ADDENDUM No. 1

May 19, 2026

**Millpond Park Plaza
City of Fenton
OHM Job No.: 0077-24-0110**

PROJECT NUMBER: PM JL
0017-24-0110
CITY OF FENTON
MILLPOND PARK PLAZA
PLANTING PLAN

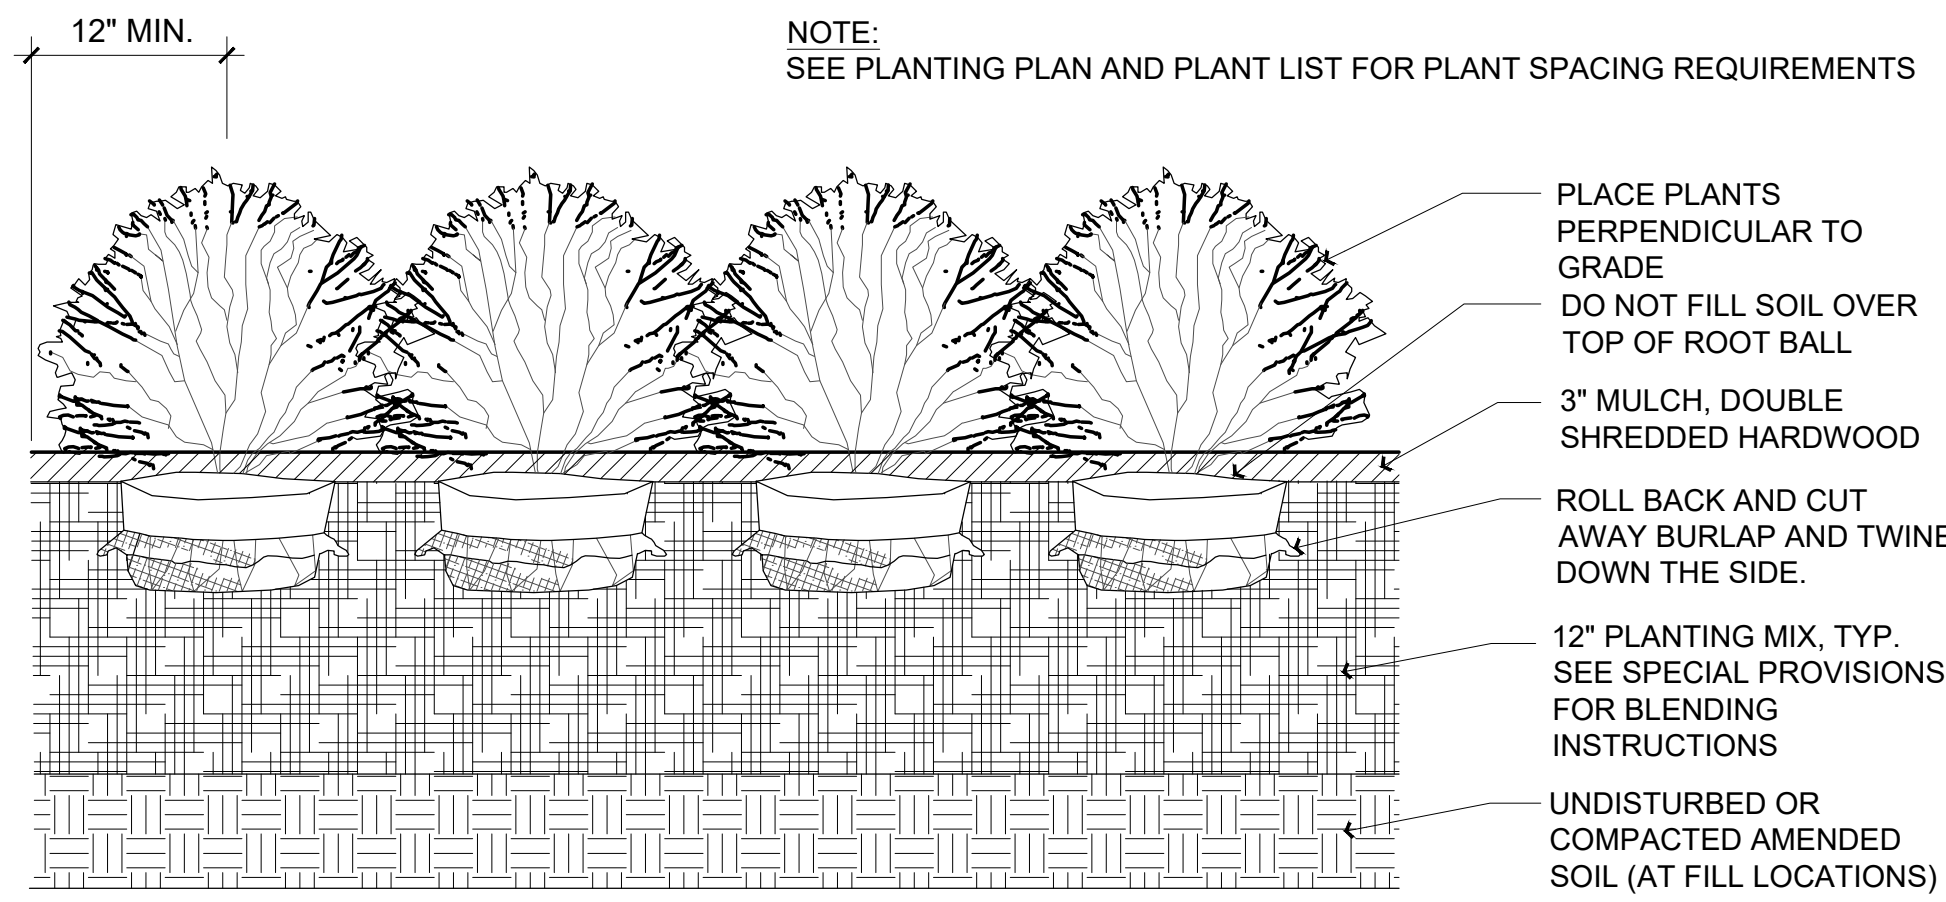
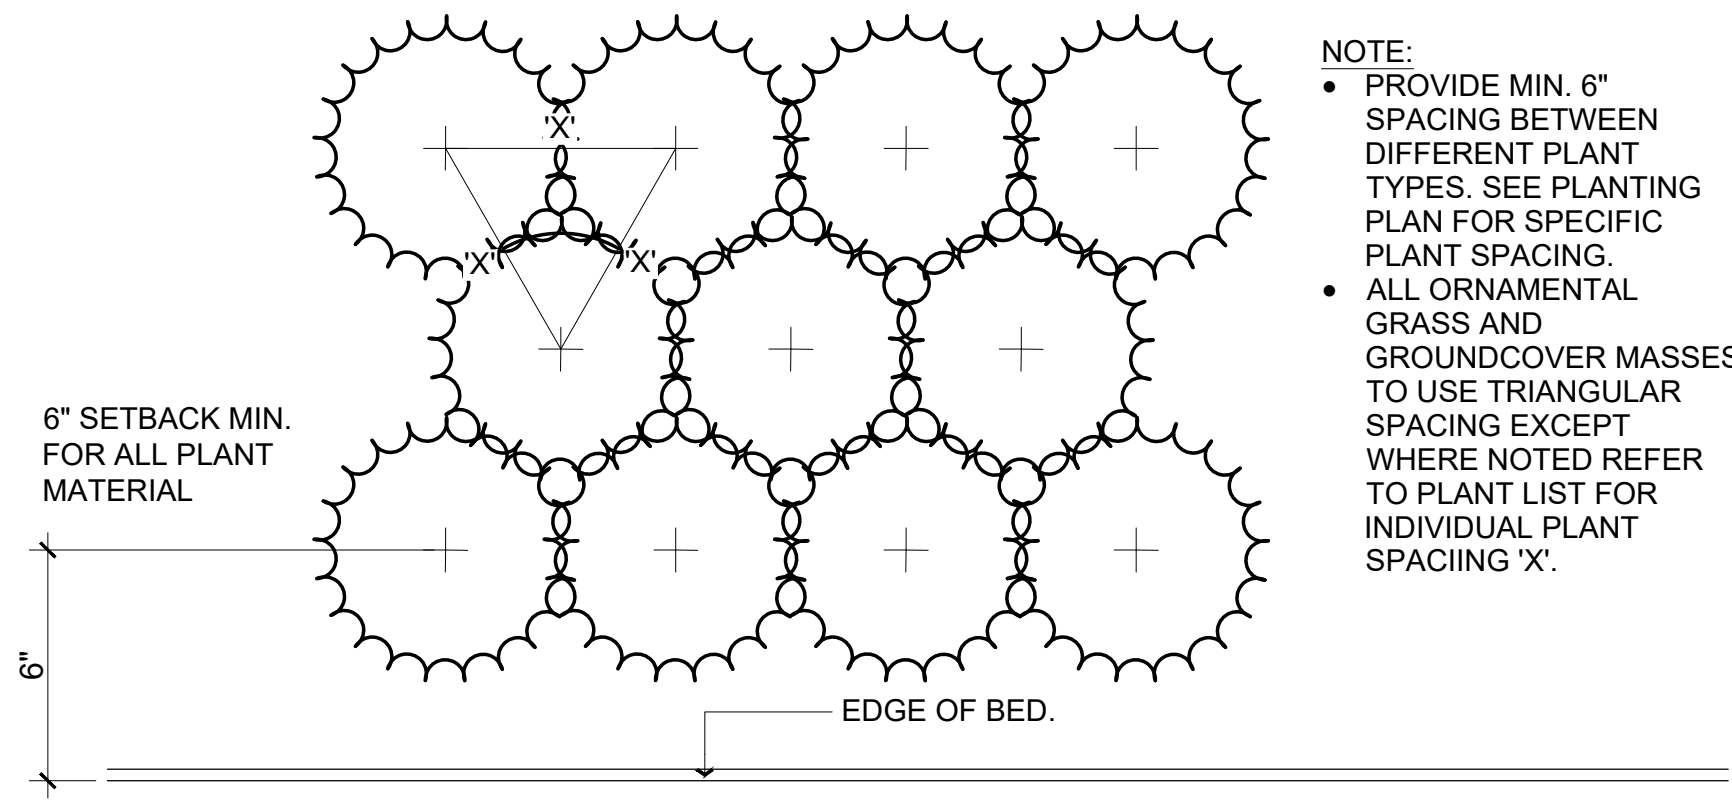
1. Delete Sheet L-400 and replace with page 5 of this addendum (Butterfly garden note)
2. Delete Sheet L-601 and replace with page 6 of this addendum (Updated detail 6)
3. Delete Sheet E-601 and replace with page 7 of this addendum (LP1 Lighting Relay Detail Updated)

- NOTES:**
1. THE CONTRACTOR SHALL COORDINATE A SPRING INSPECTION OF THE EXISTING BUTTERFLY GARDEN PLANTINGS WITH THE OWNER AND THE LANDSCAPE ARCHITECT TO INVENTORY THE GARDEN AND DETERMINE EXISTING PLANT HEALTH. UPON COMPLETION OF THIS INSPECTION, THE OWNER WILL DETERMINE THE EXTENT OF NEW AND/OR REPLACEMENT PLANTINGS TO BE COMPLETED IN THE BUTTERFLY GARDEN.

6 BUTTERFLY GARDEN BRICK PAVERS
SCALE: 1-1/2" = 1'-0"

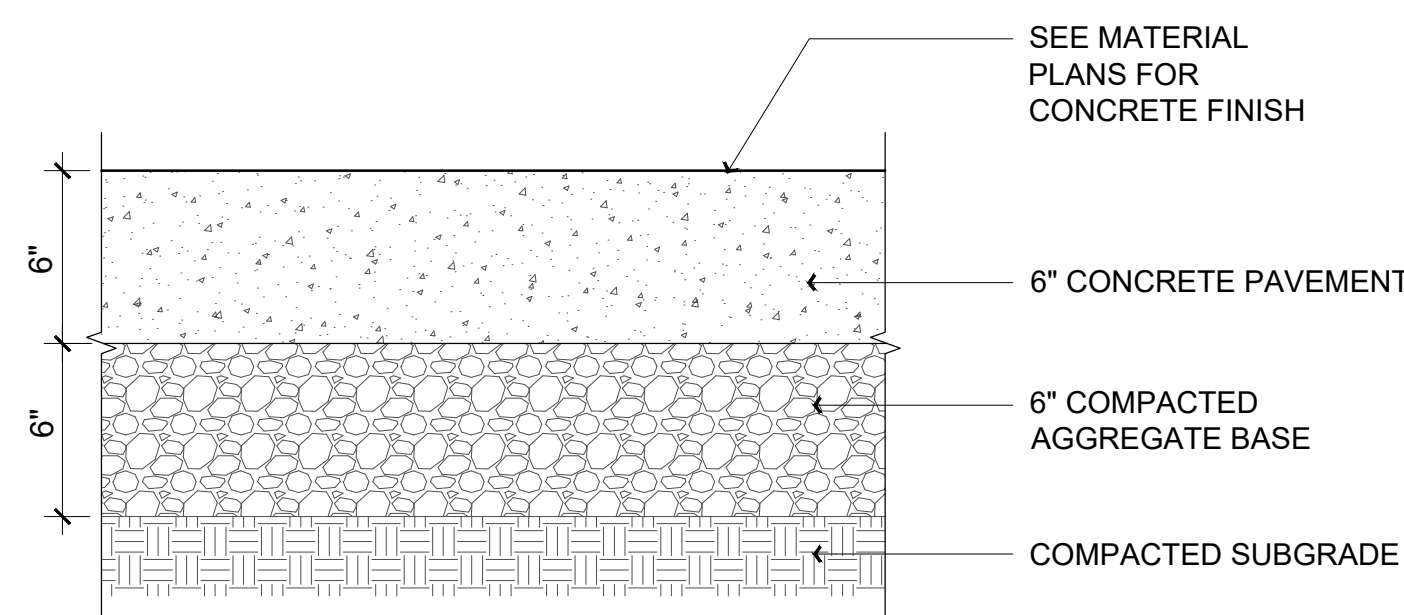
9. What is the specified base material for the Butterfly patio extension, concrete or aggregate material?
 - a. 10-12 inches of aggregate base material was used under the existing bricks. All new and relocated brick pavers should have a matching amount of base material. Detail 6 on sheet L-601 has been updated to reflect this.

1 LP1 LIGHTING RELAY PANEL DETAIL
NTS

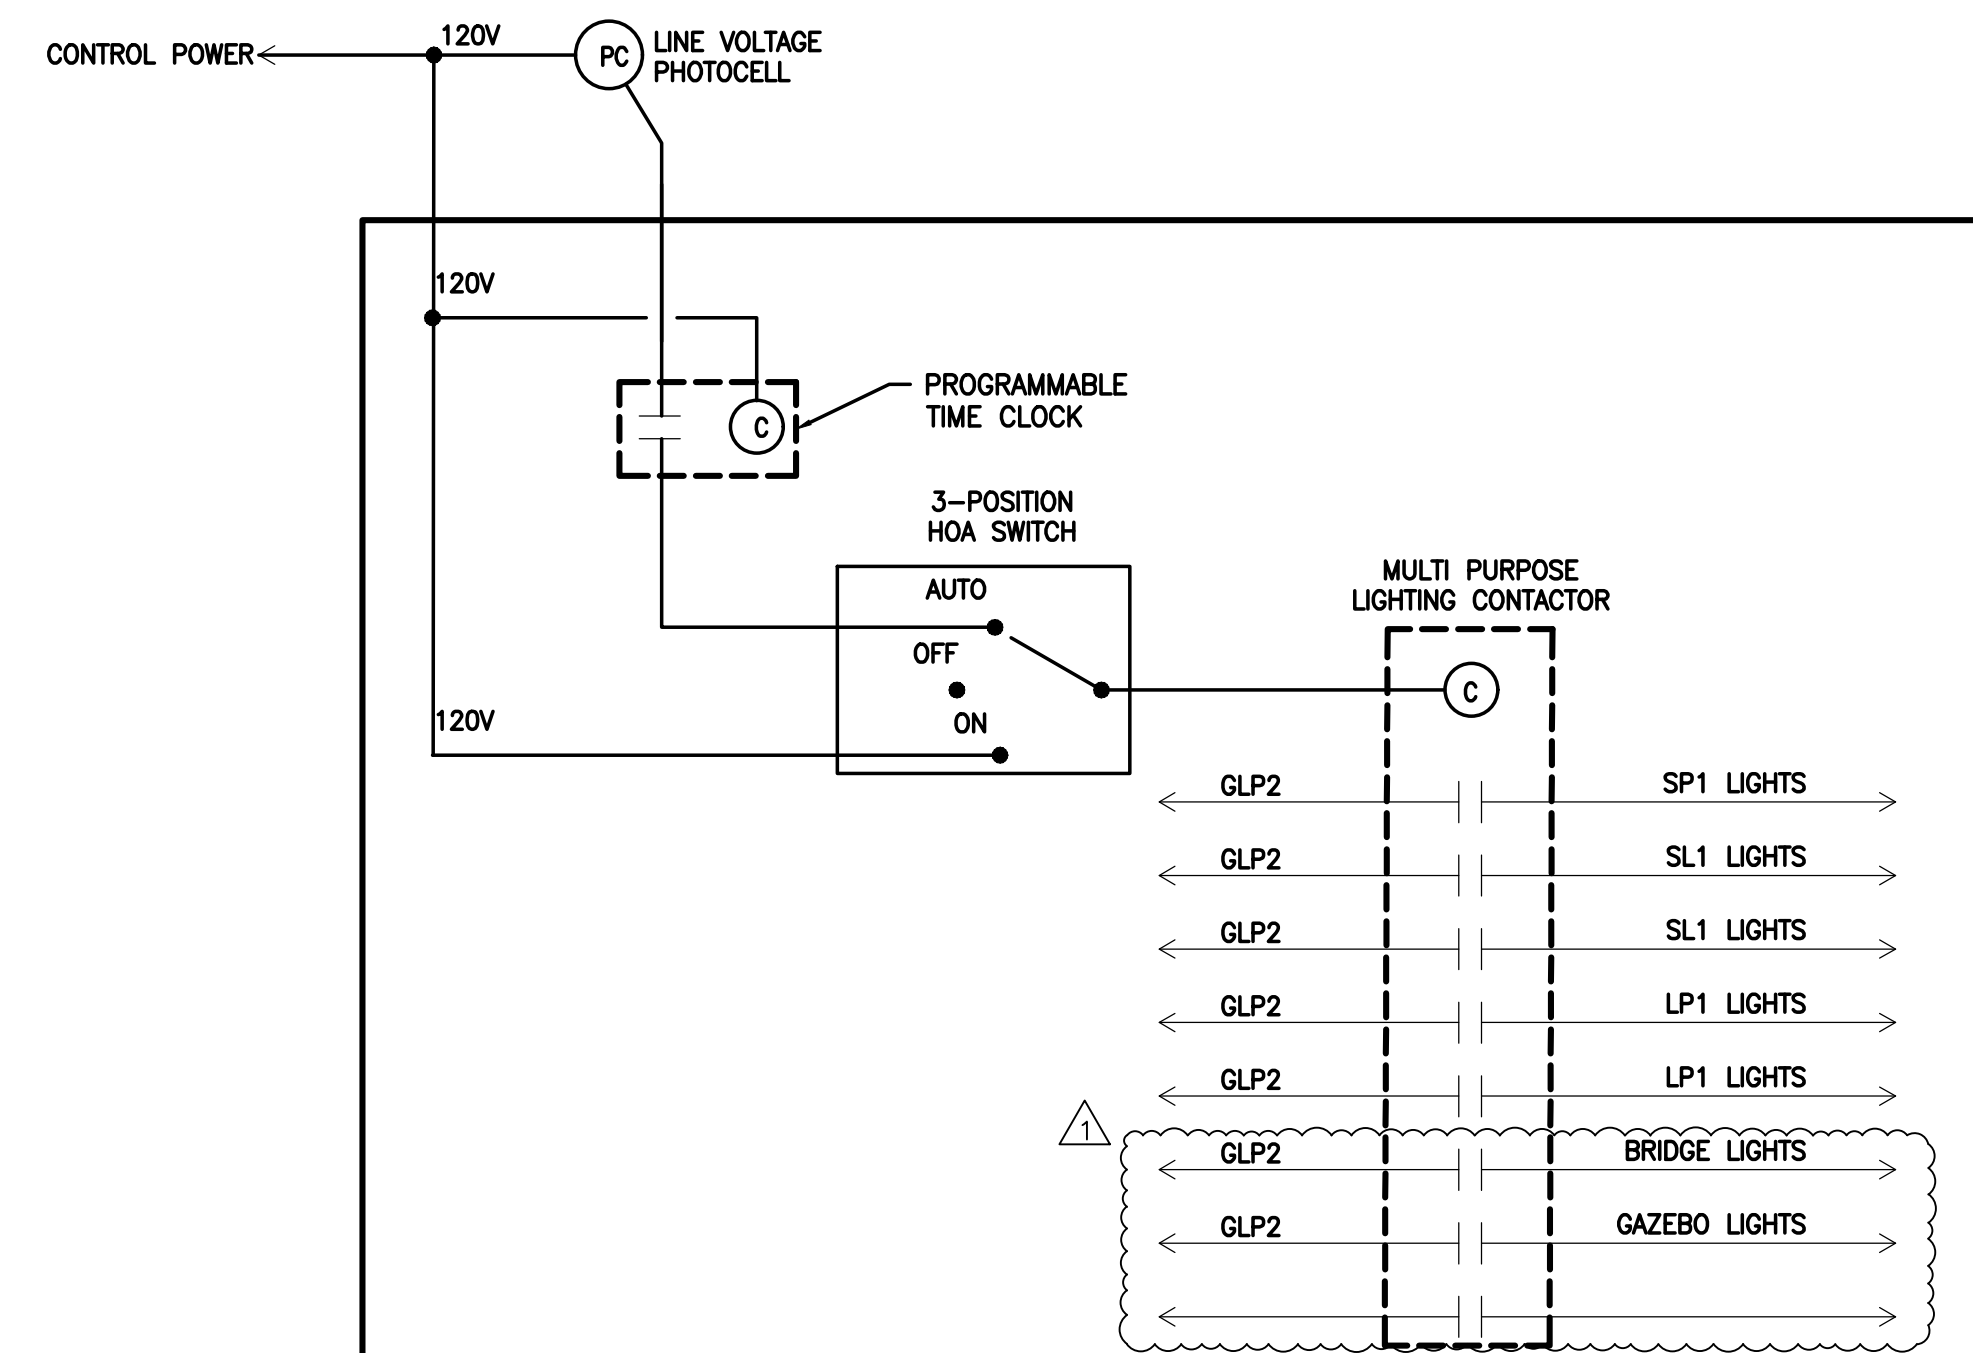
4. Do we need a larger contactor that includes the bridge and gazebo? Maybe 8 instead of 5?
 - a. The contactor has been revised on plan sheet E-601 to be a 10-space unit. This will include the bridge and the gazebo lights. Refer to
